**Economic and Social Council**Distr.: General
24 November 2017

Economic Commission for Europe**Inland Transport Committee****World Forum for Harmonization of Vehicle Regulations****Working Party on Passive Safety****Sixty-second session**

UN Regulation No. 129 (Lateral collision)**Proposal for Supplement 3 to the 02 series of amendments to
UN Regulation No. 129 (Enhanced Child Restraint Systems)****Submitted by the expert from France***

Figures of Strapped child

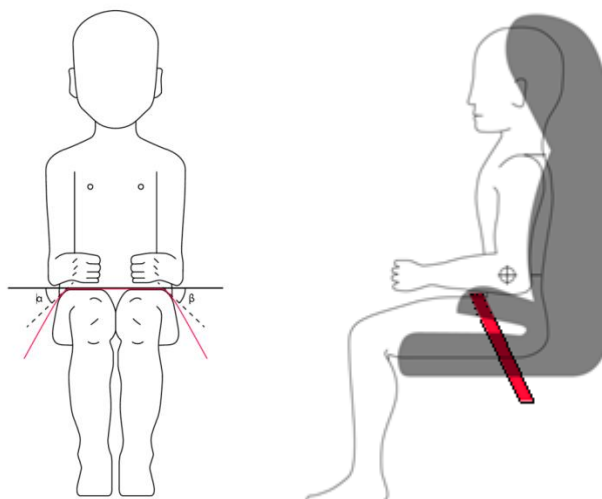
Paragraph 6.2.1.5., amend to read:

In the case of booster seats, the lap portion of the adult safety-belts shall be positively guided on both sides to ensure that the loads transmitted by the adult lap belt are transmitted through the pelvis. The positive guidance of loads over the pelvis shall be realised from the moment that the child is installed; the lap belt shall pass over the top of the thigh, just touching the fold with the pelvis. The angles α and β between the tangent line in which the belt touches the thighs and the horizontal shall be greater than 10°.

Figure 2
Arrangement for testing a rearward-facing device, not supported by the dashboard

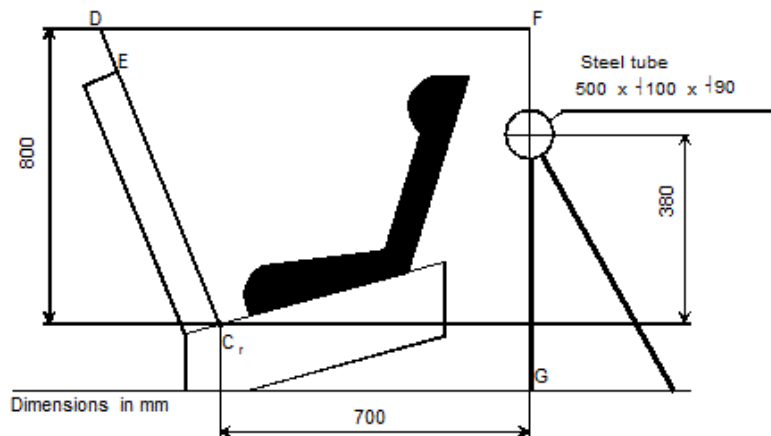
Paragraph 6.6.4.4.1.2.1., amend to read:

"6.6.4.4.1.2.1. Head excursion: no part of the head of the dummy shall pass beyond the planes FD, FG and DE, as shown in figure 2 below. This shall be judged up to 300 ms or the moment that the dummy has come to a definitive standstill whatever occurs first.

Except when testing using Q6 or Q3 dummy where the value in relation to the FD plane is 840 mm.

Where a test is conducted with paragraphs 6.6.4.1.6.1.1.2., 6.6.4.1.6.1.2. or paragraph 6.6.4.1.8.2. above, only the second configuration test results without 100 mm diameter bar will be considered.

Figure 4

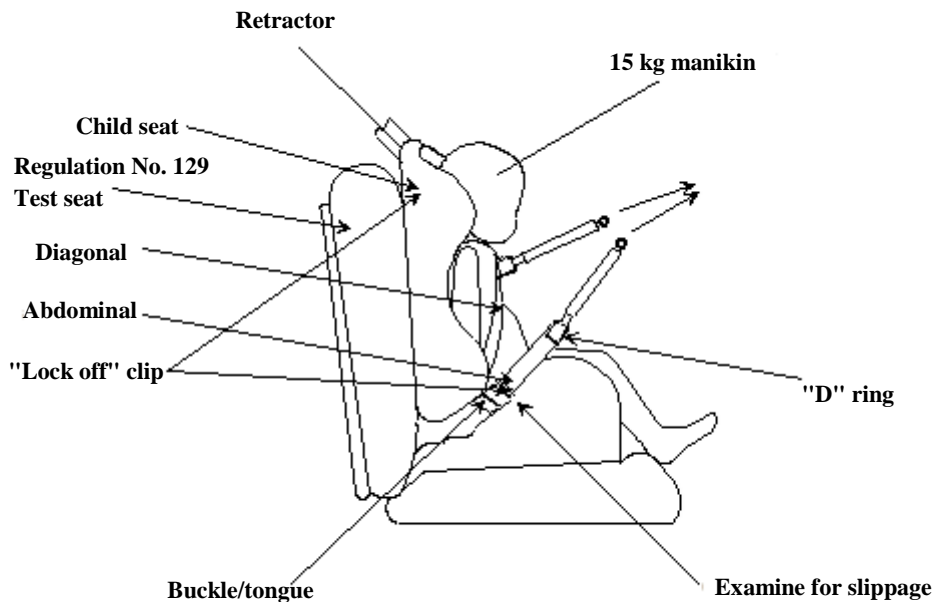
Insert new paragraphs 7.2.9. to 7.2.9.2., to read:

7.2.9.1. Class A devices

The child restraint and the largest manikin for which the child restraint is intended shall be set up as shown in Figure 4 below. The webbing used shall be as specified in Annex 23 to this UN Regulation. The lock-off shall be fully applied and a mark made on the belt where the belt enters the lock-off. The force gauges shall be attached to the belt via a D ring, and a force equal to twice (±5 per cent) the mass of the heaviest dummy of group I shall be applied for at least one second. The lower position shall be used for lock-offs in position A and the upper position for lock-offs in

position B. The force shall be applied for a further nine times. A further mark shall be made on the belt where it enters the lock-off and the distance between the two marks shall be measured. During this test, the retractor shall be unlocked.

"Annex 2

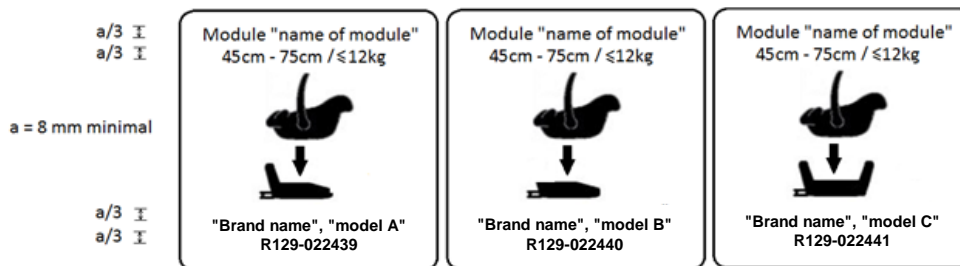
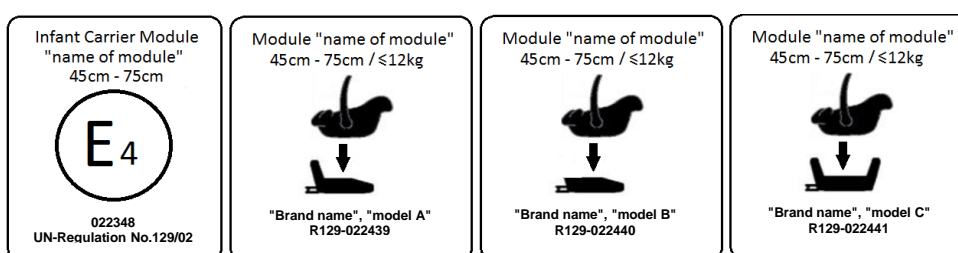
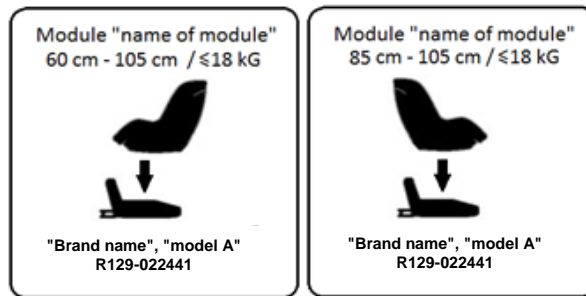
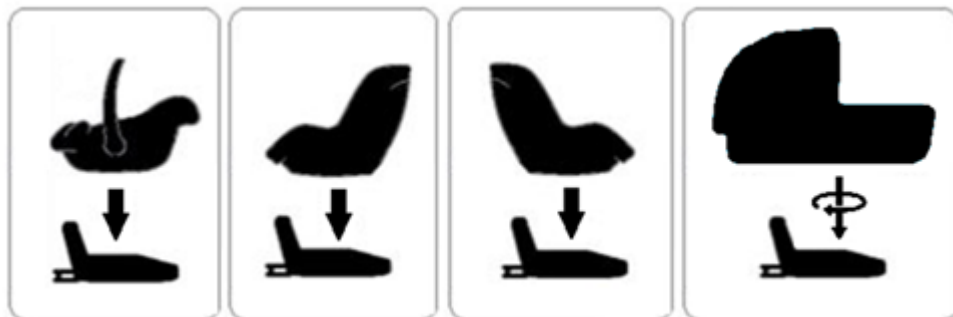
Annex 2, replace current Annex 2 by the following to read:

1. **Arrangements of the approval mark**
...
2. **Arrangements of the approval mark in combination with a module mark**
...
- 2.1. **Arrangements of the module mark in combination with an approval mark**
- 2.1.1. **Where a module is approved for use with more than one base, the individual base and module combinations shall be indicated on the module in separate module marks, each bearing their applicable size ranges.**

- 2.1.2. Where a module is capable of being installed in different orientations, separate module marks shall be indicated on the module, each bearing their applicable size ranges.

- 2.2. Examples of the symbols to be used on the module mark are given in the figures below. As chosen by the Enhanced Child Restraint Systems manufacturer, one of the symbols or an equivalent shall be used on the module mark.

Figure 1
Procedure type 1

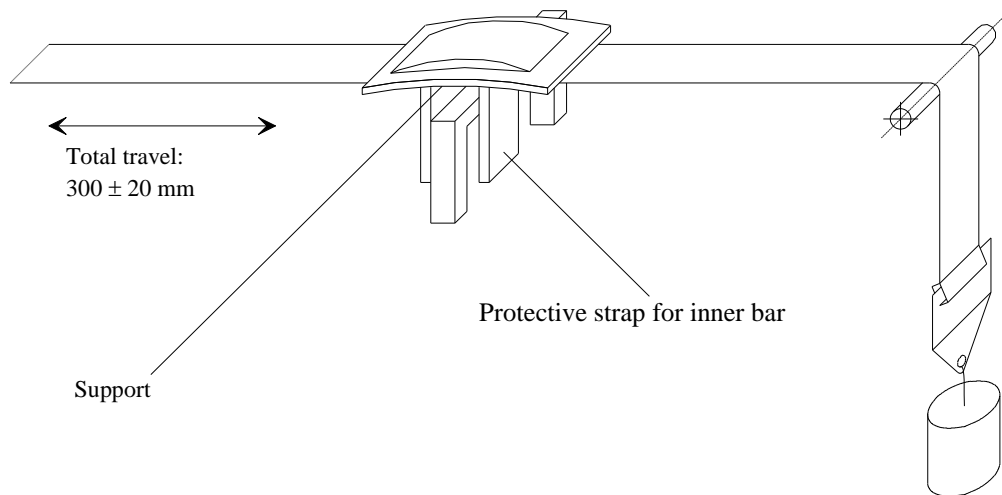
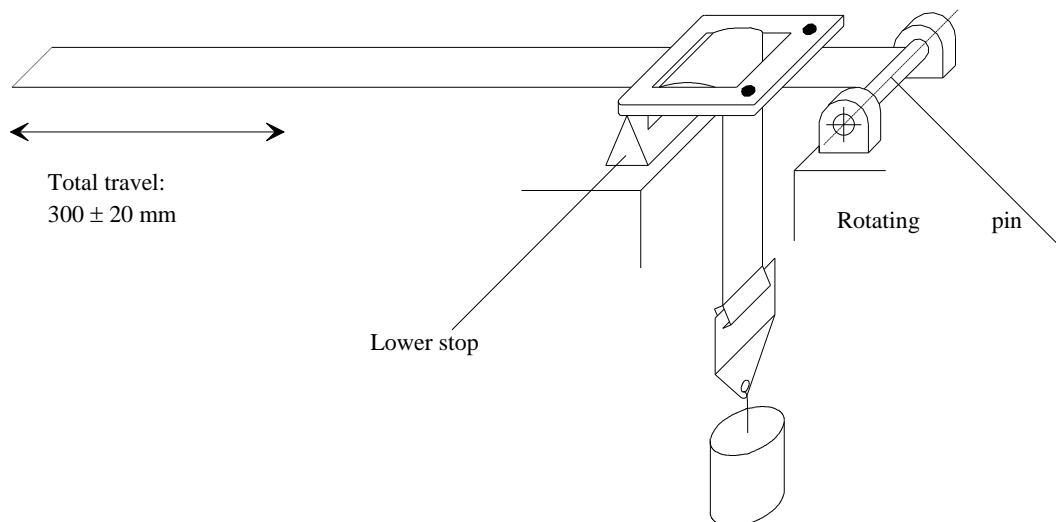
Annex 5, Figures 1 and 2, amend to read:

$F = 10 \pm 0.1 \text{ N}$, can be increased up to $F = 60 \pm 0.5 \text{ N}$ (see table 8, paragraph 7.2.5.2.6.2.)

$F = 10 \pm 0.1 \text{ N}$, can be increased up to $F = 60 \pm 0.5 \text{ N}$ (see table 8, paragraph 7.2.5.2.6.2.)

Figure 2
Procedure type 2
 Following two examples of test set up

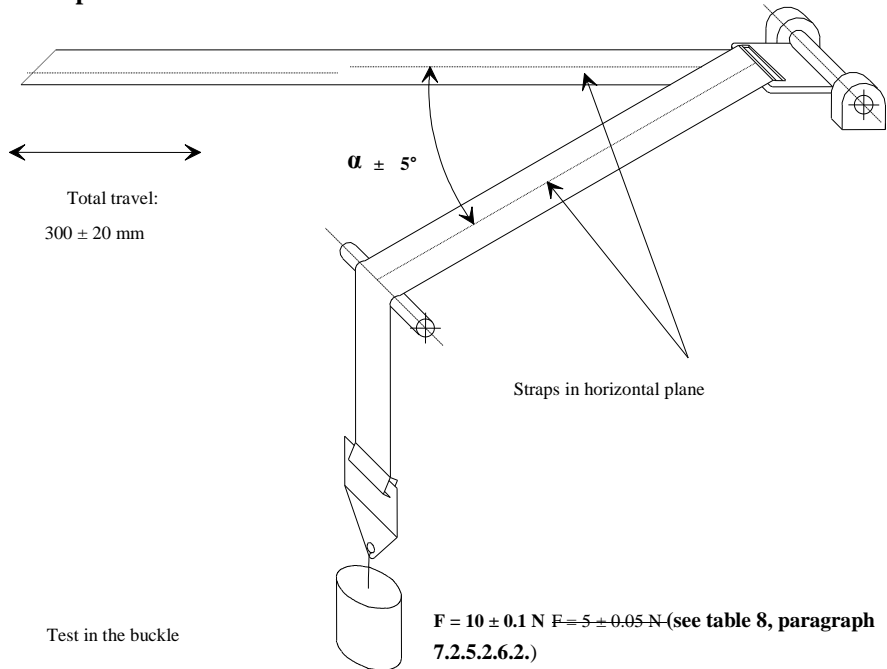
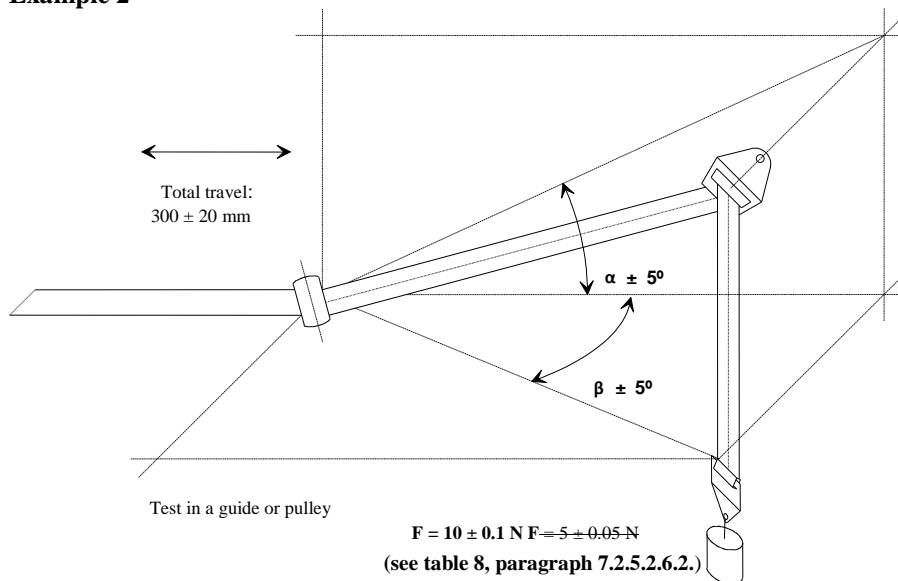
Where α and β reproduce the angles as in the real installation (in three dimensions) ..."

Figure 3
Side and Front View of the measuring device for measurements applicable to Enhanced Child Restraint Systems that feature an impact shield

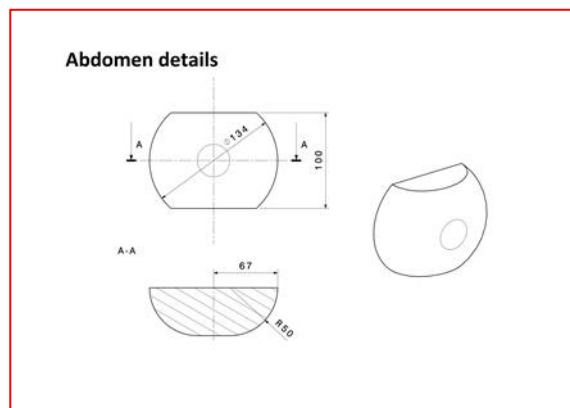
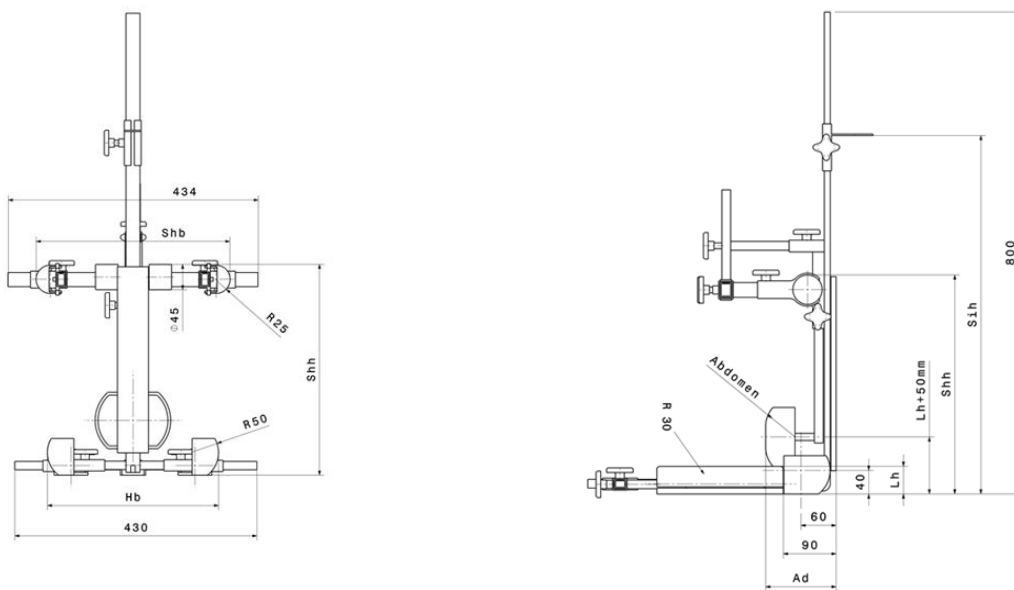
Annex 18, amend to read:
